ADDENDUM #4

Bid 19C14, Rock Creek School Replacement Project <u>REVISED DUE DATE & TIME:</u> FCPS Main Lobby, Wednesday, August 7, 2019, prior to and time stamped no later than 2:00 P.M.

Project: Rock Creek School Replacement

ADDENDUM NO. 4

C-3B

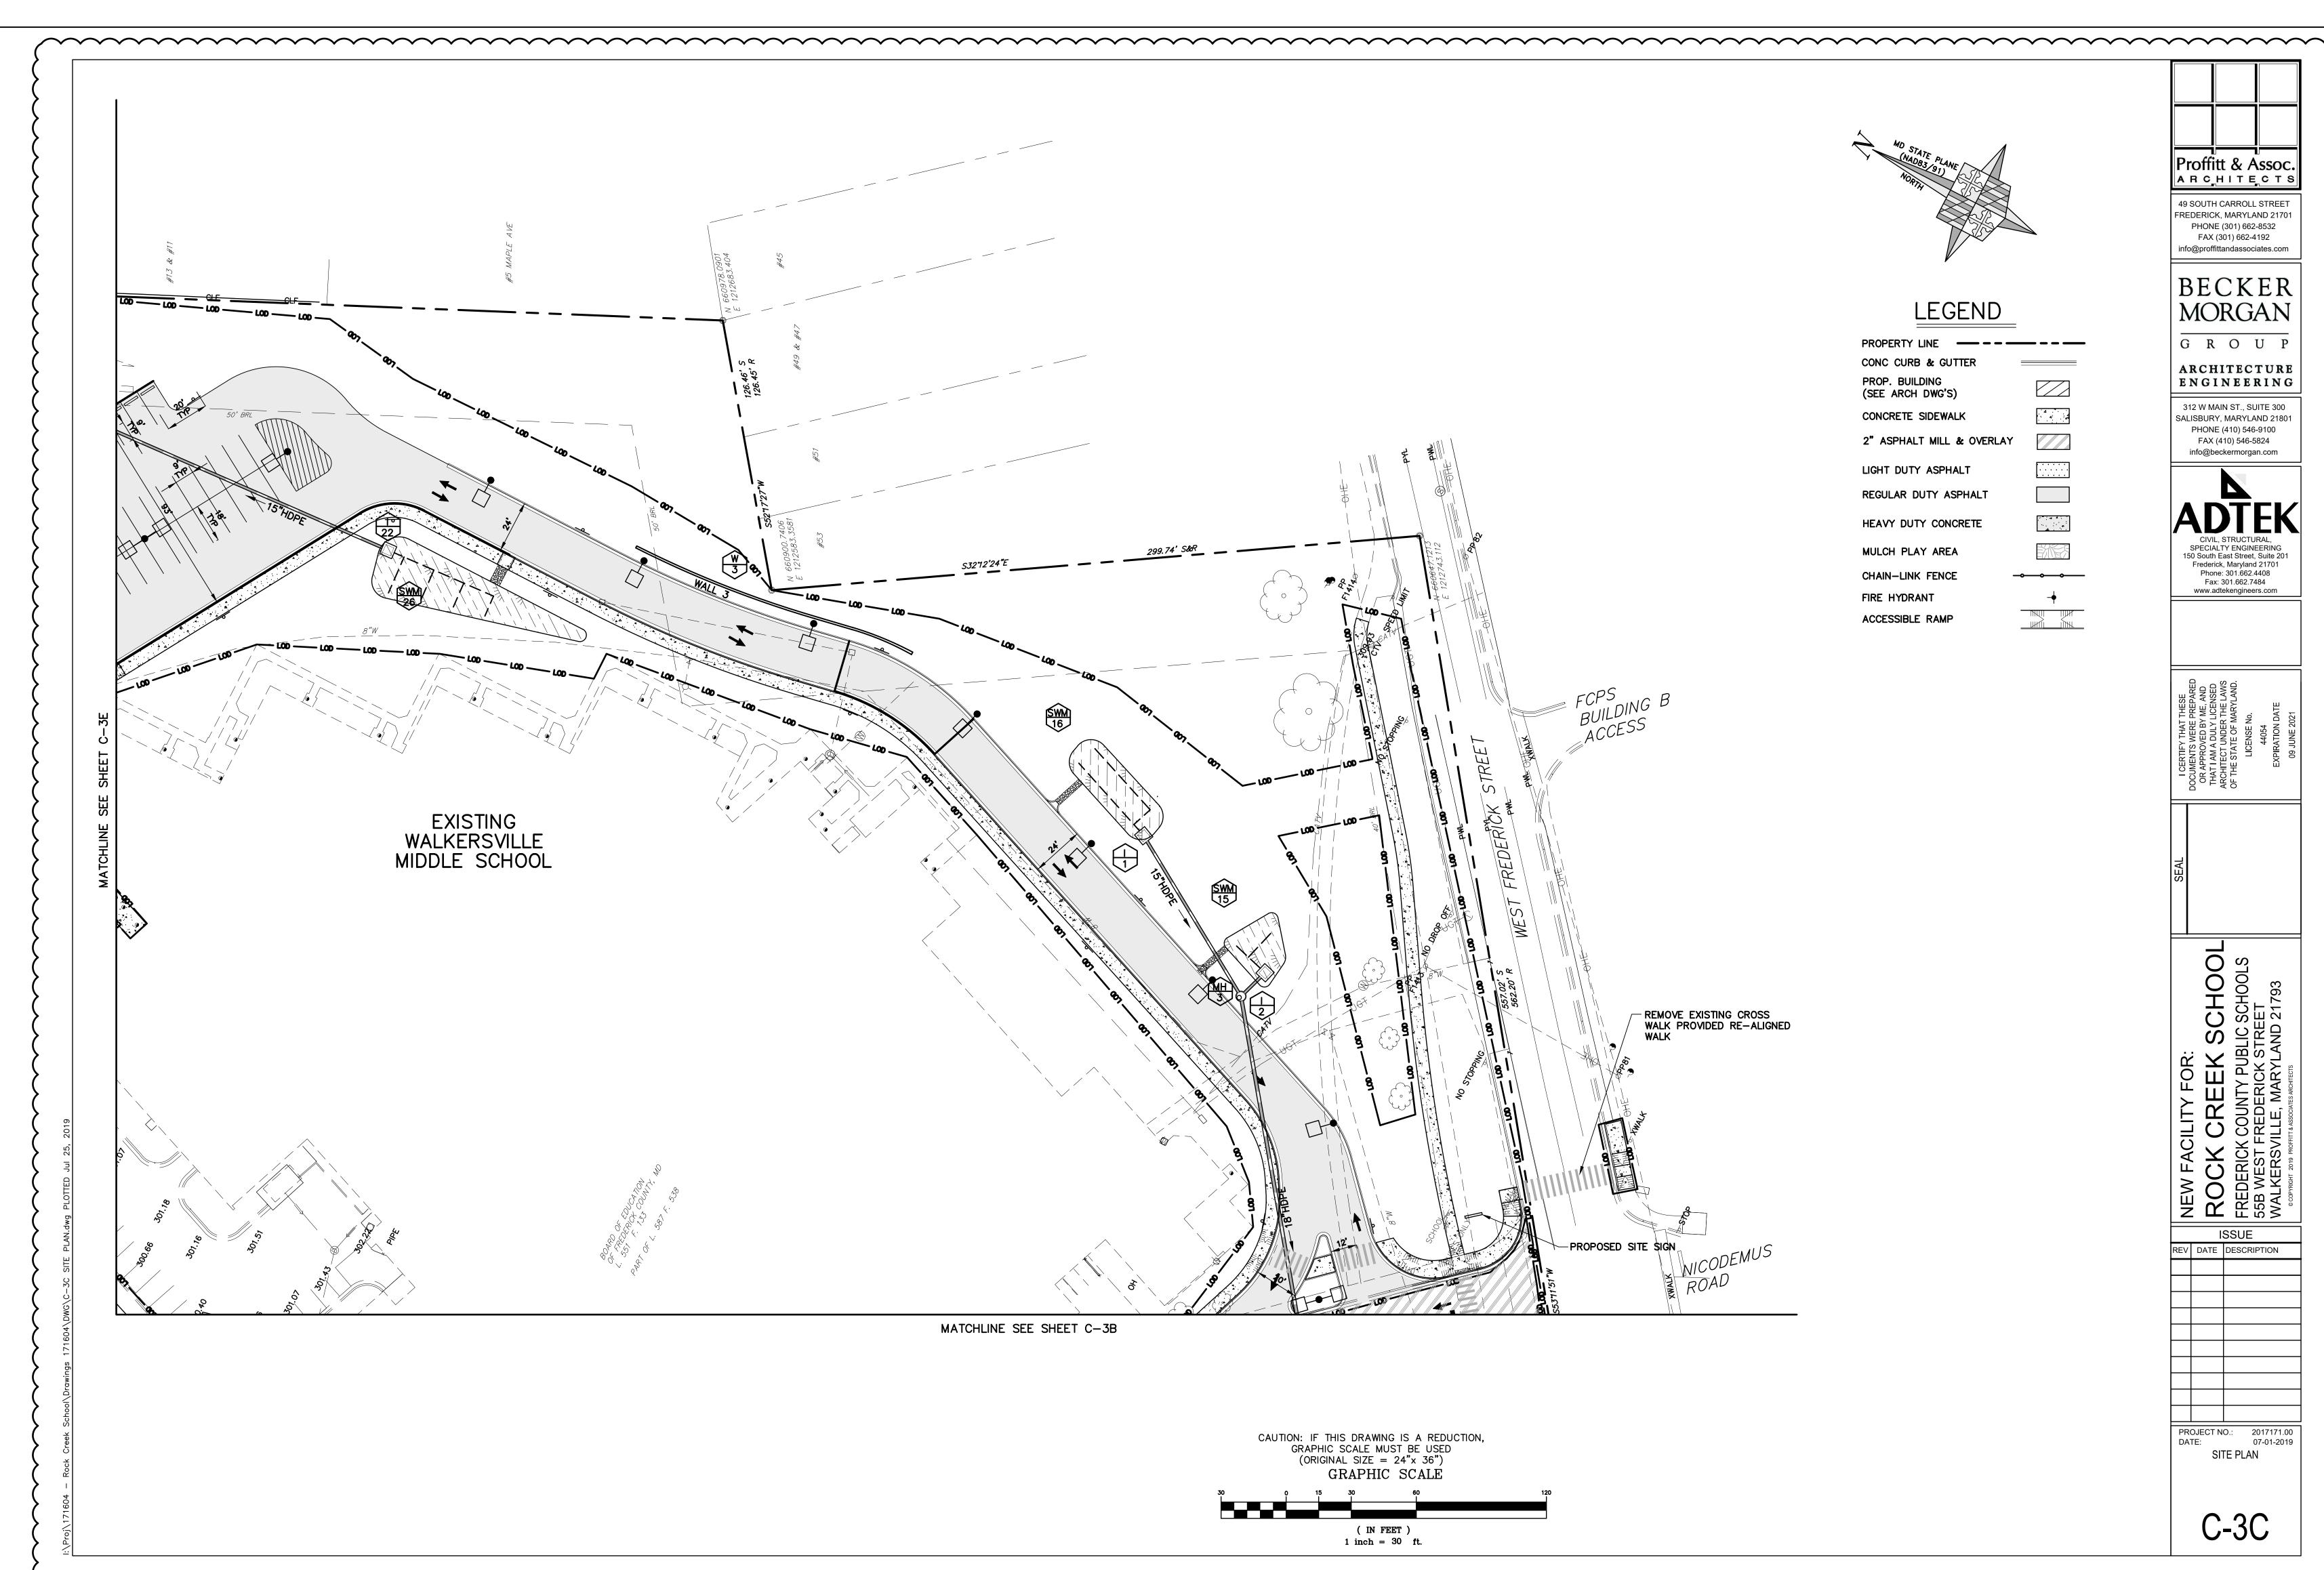
REVISE – entire sheet in response to RFI's

PROJECT NO.: 2017171.00
DATE: 07-01-2019
ROOF FRAMING
PLAN - AREA D

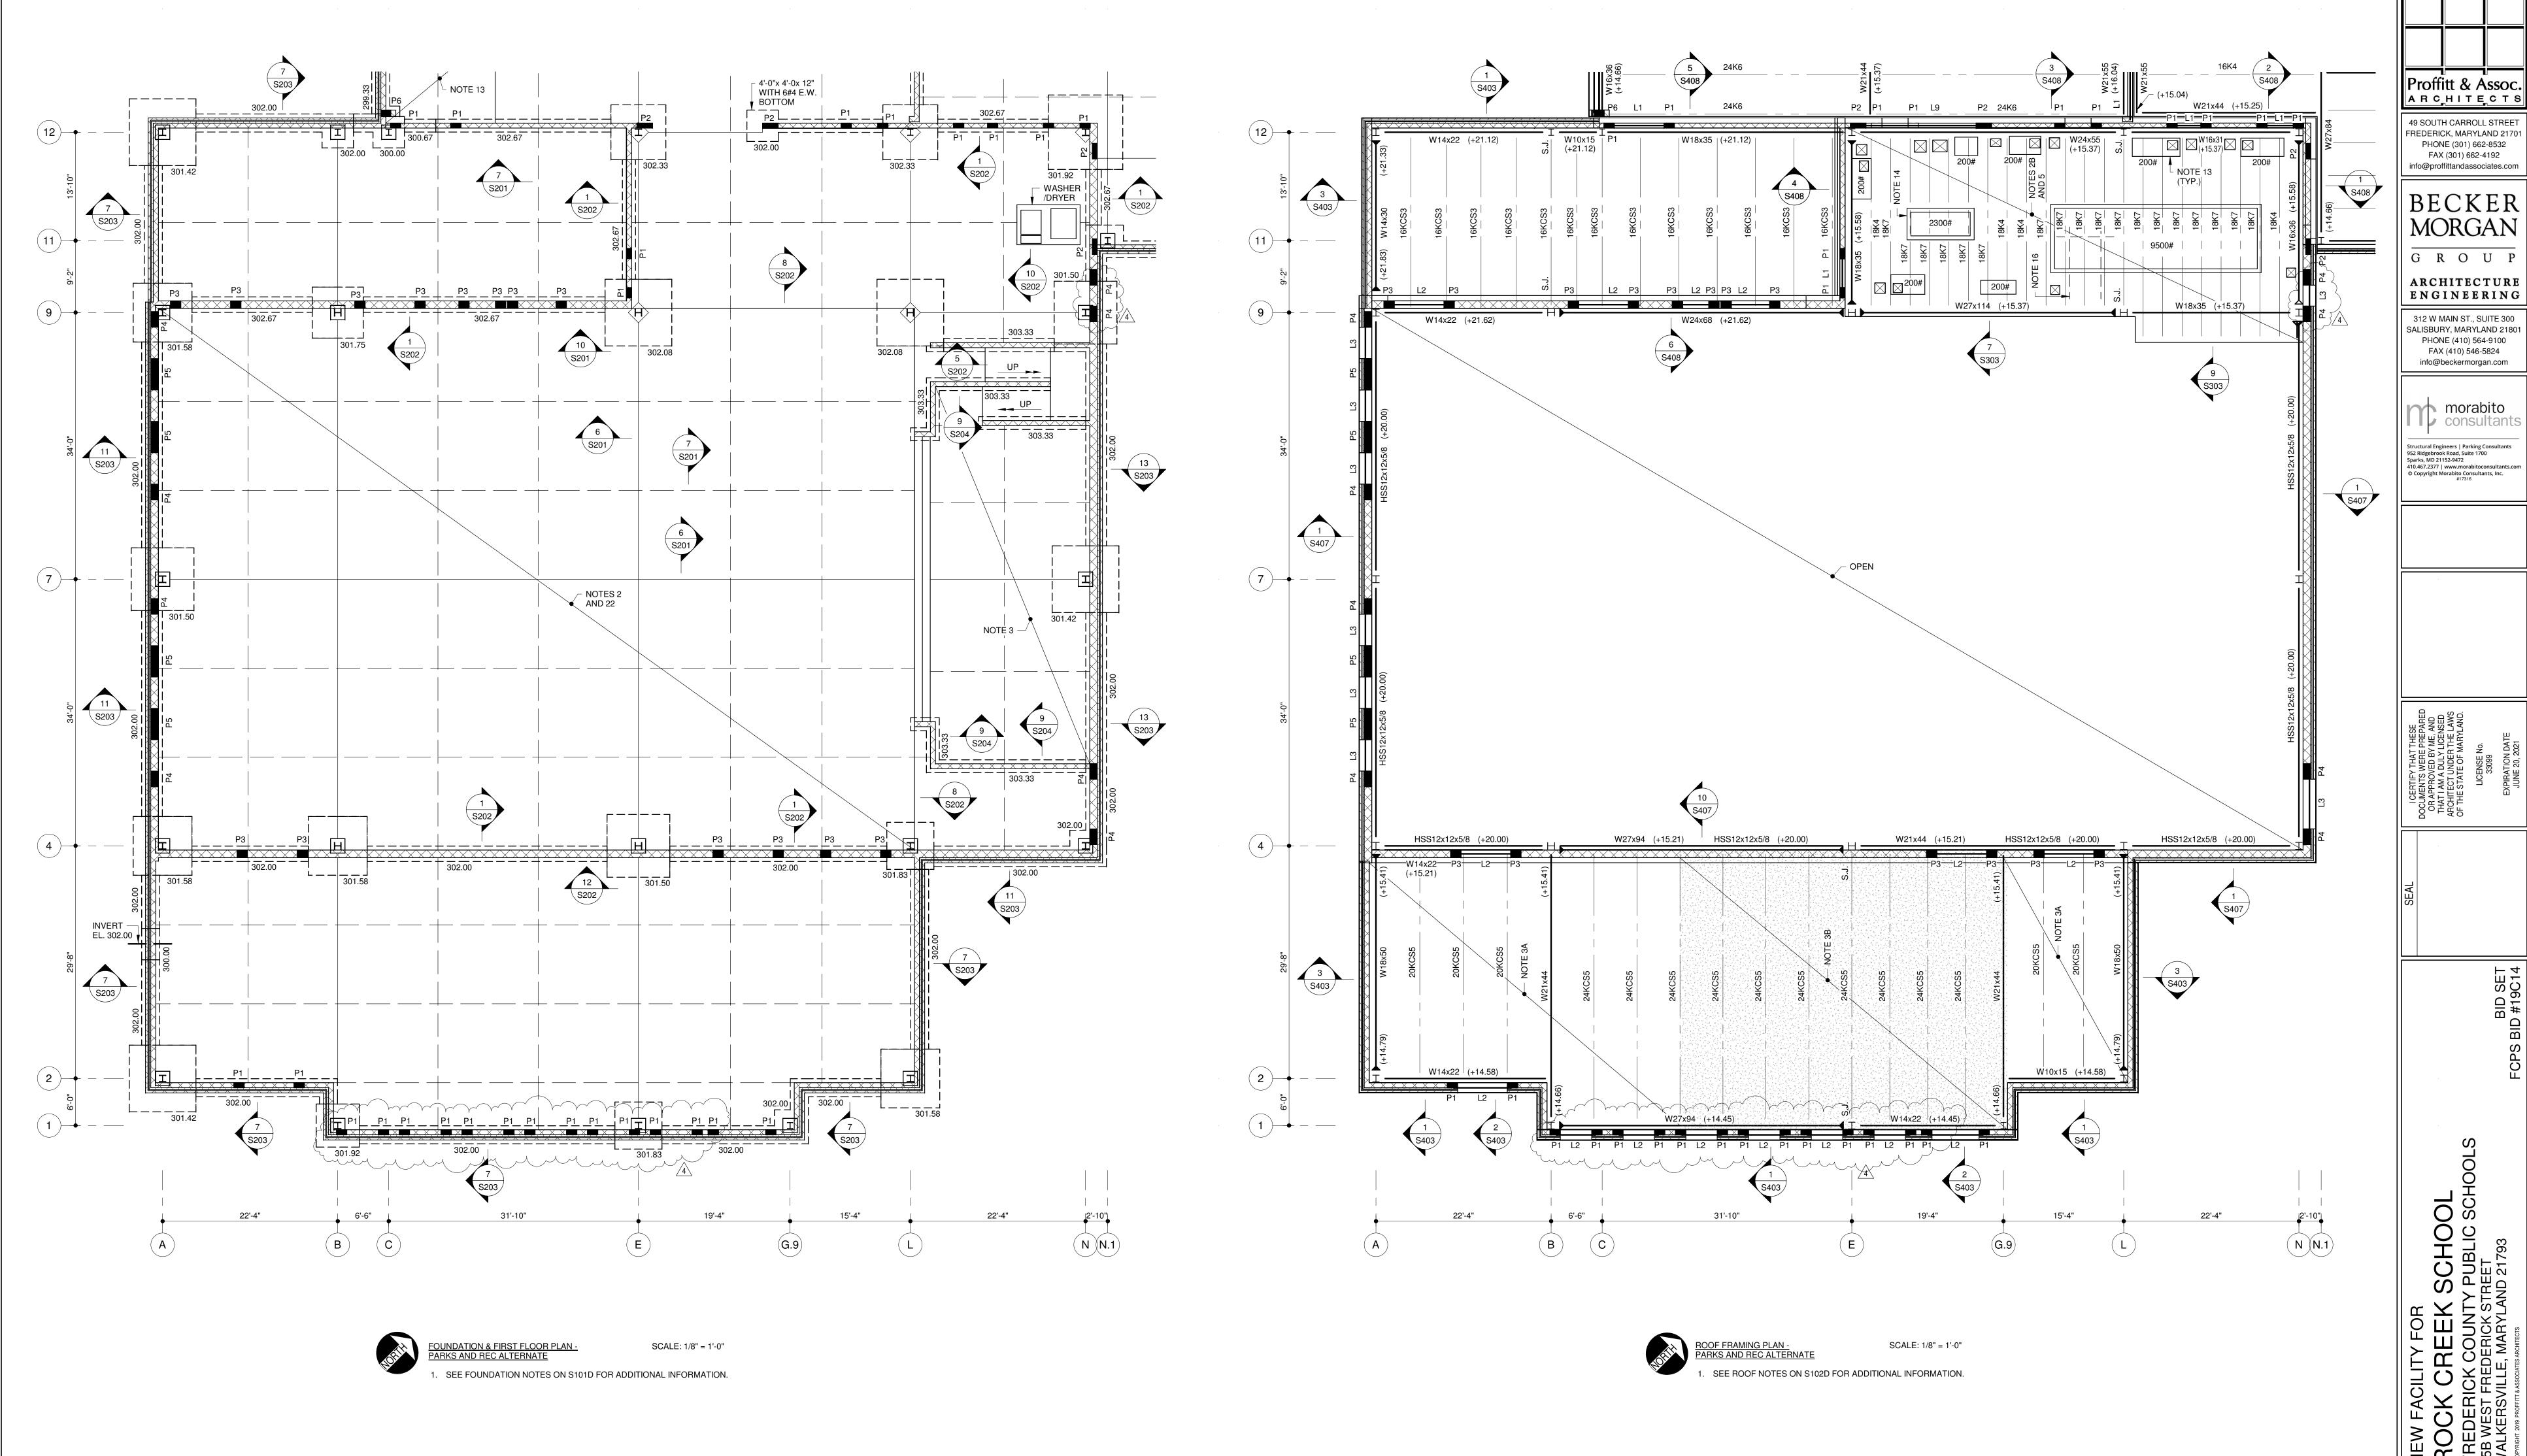
CLARIFY – Lintel locations at Gymnasium

PARK AND REC ALTERNATE PLANS (ALT #1)

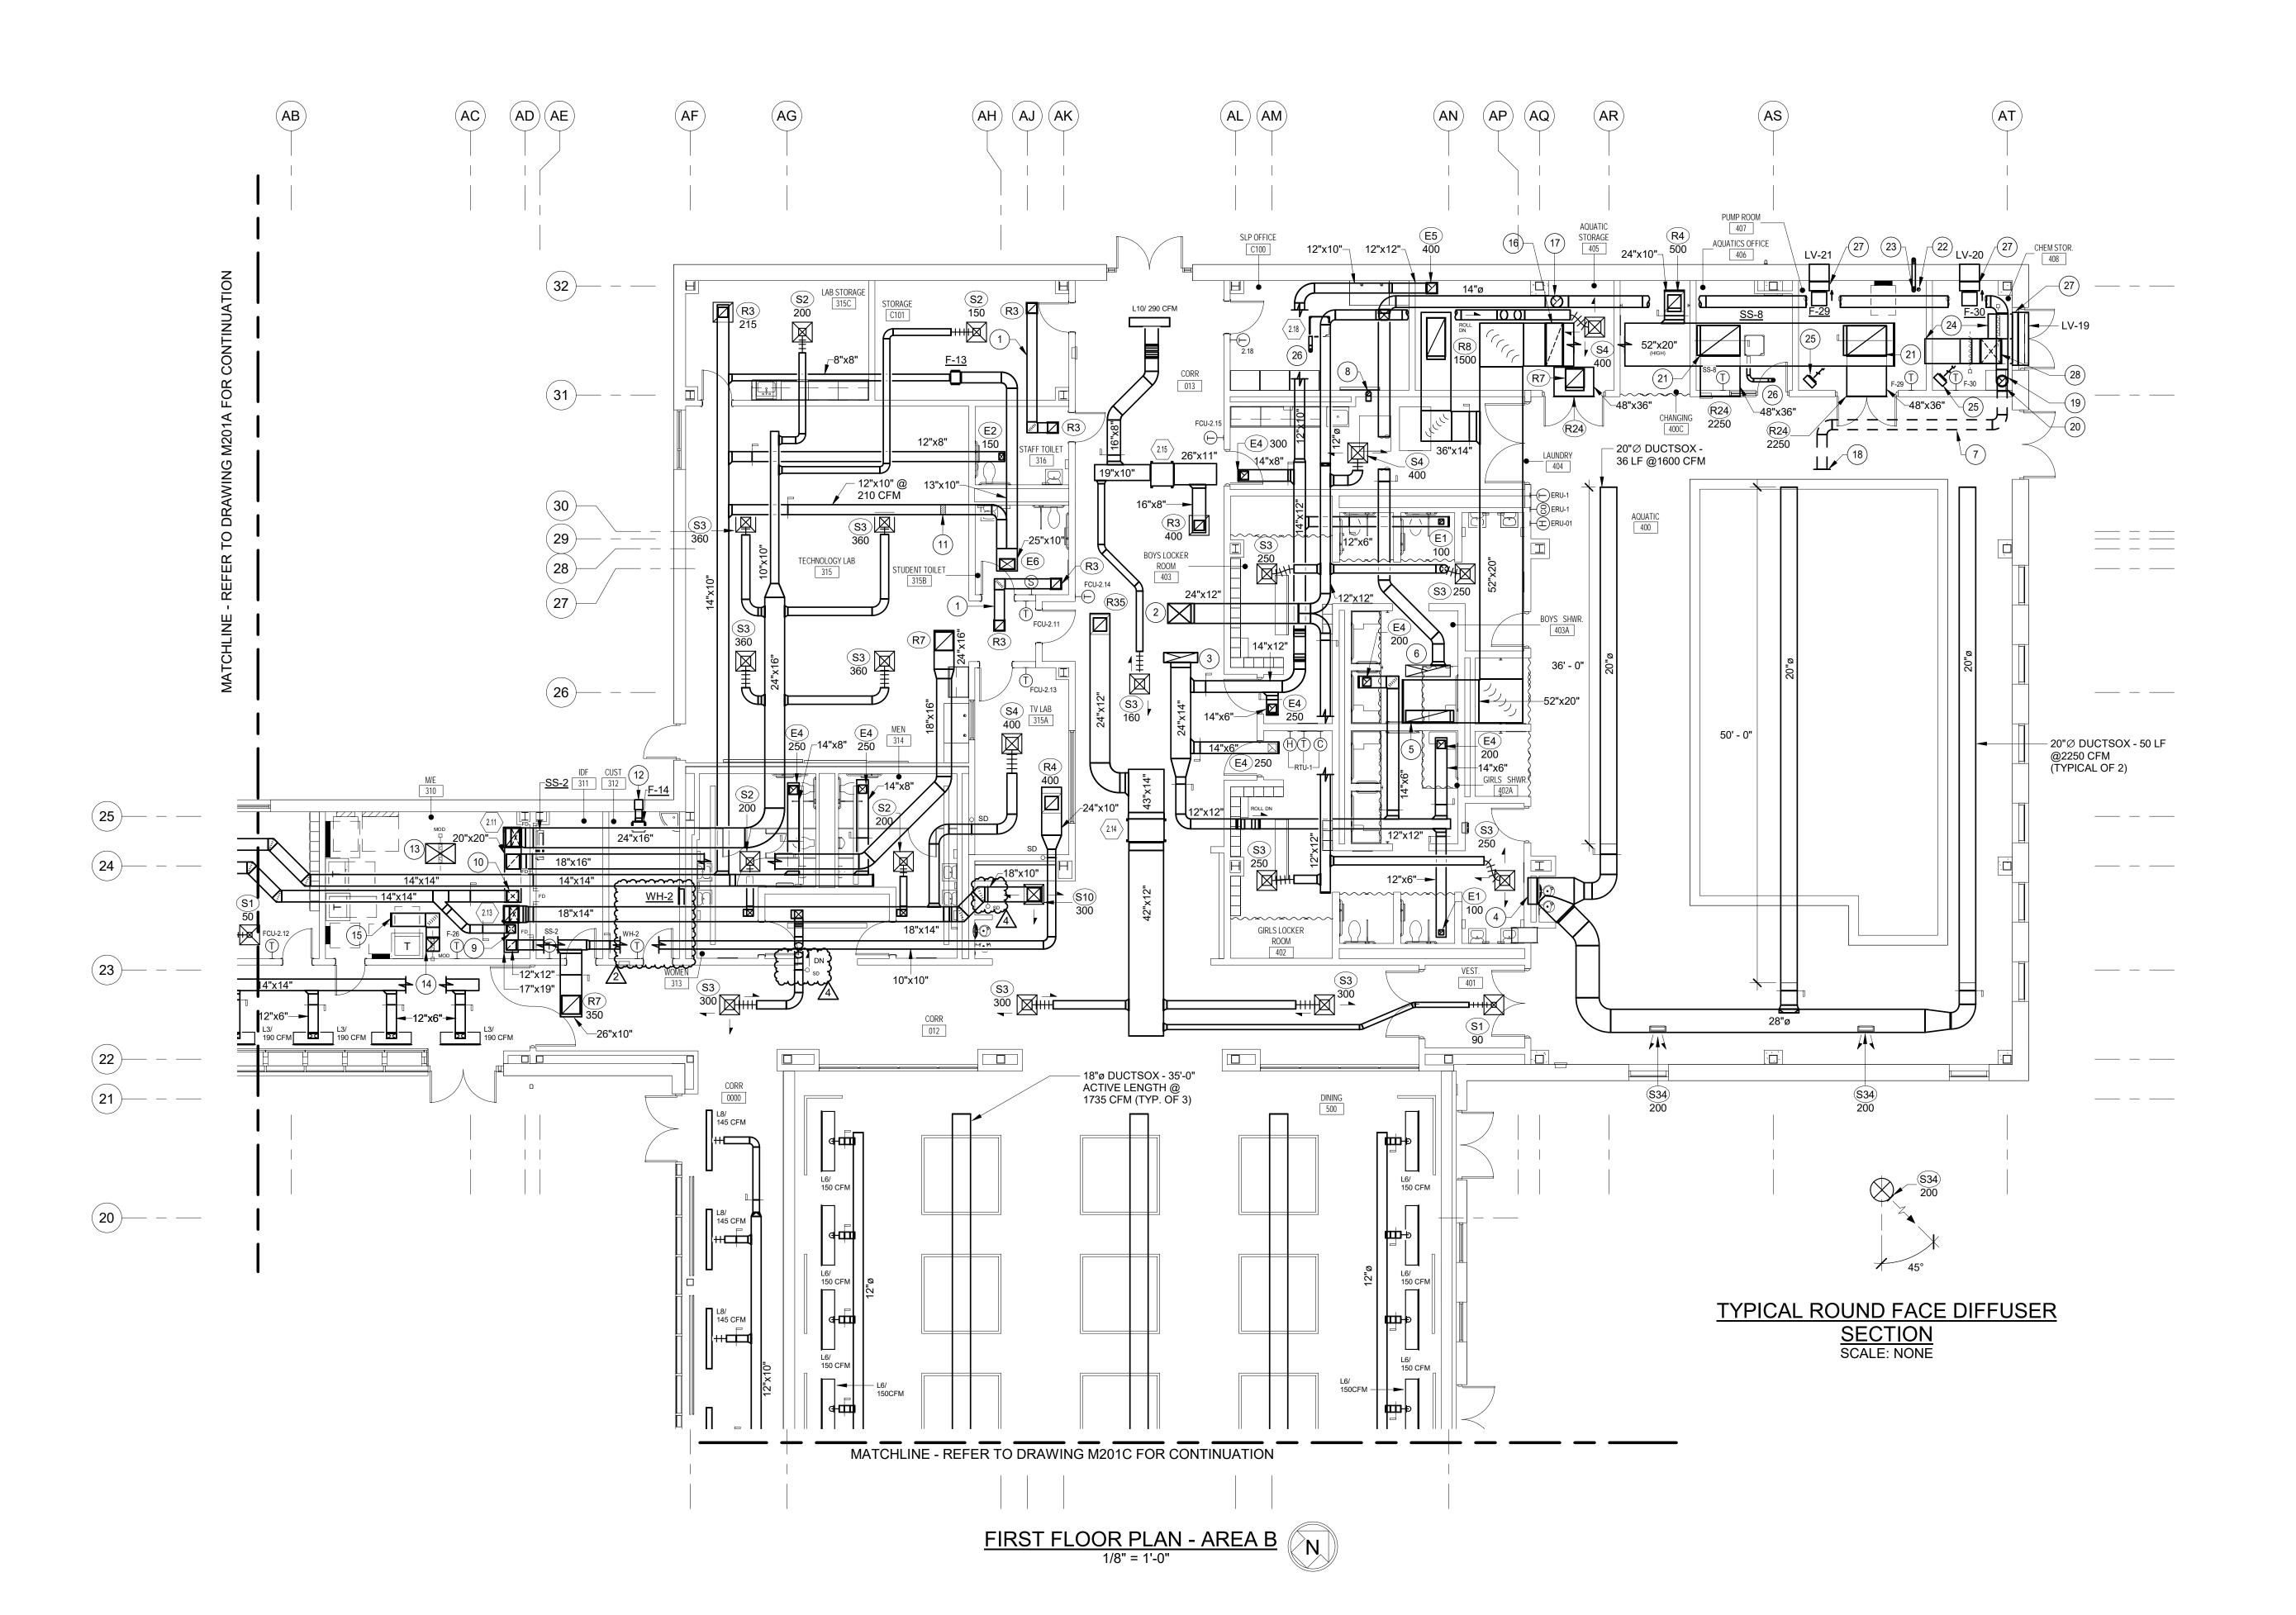
CLARIFY – Lintel locations at Gymnasium
